LODI UNIFIED SCHOOL DISTRICT

LODI HIGH SCHOOL DEMOLITION & NEW FLOORING IN SIX CLASSROOMS
PROJECT NUMBER: 0825-8425-4

ADDENDUM NO. 1

March 1, 2024

SOUTH PACIFIC AVENUE
PARTIAL ELECTRICAL SITE PLAN
SCALE: 1" = 30'-0"

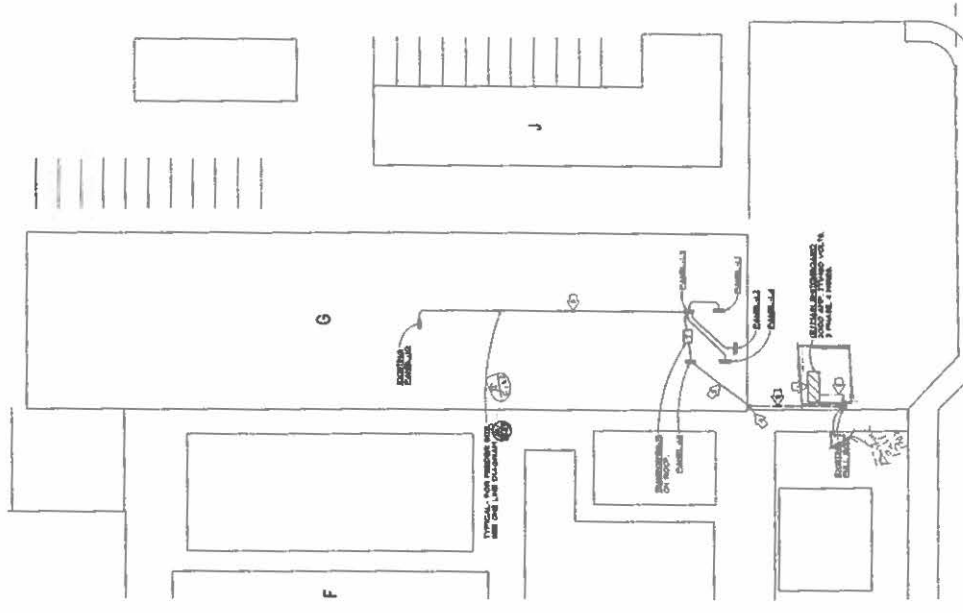
Question: Are the IDF cabinets located in each classroom?

2. Where are the electrical panels located for wire and breaker removal? **Response:** They are in the Mechanical rooms attached to each building. (SEE MAP)

Response: No, they are in the adjacent hallway. (SEE MAP)
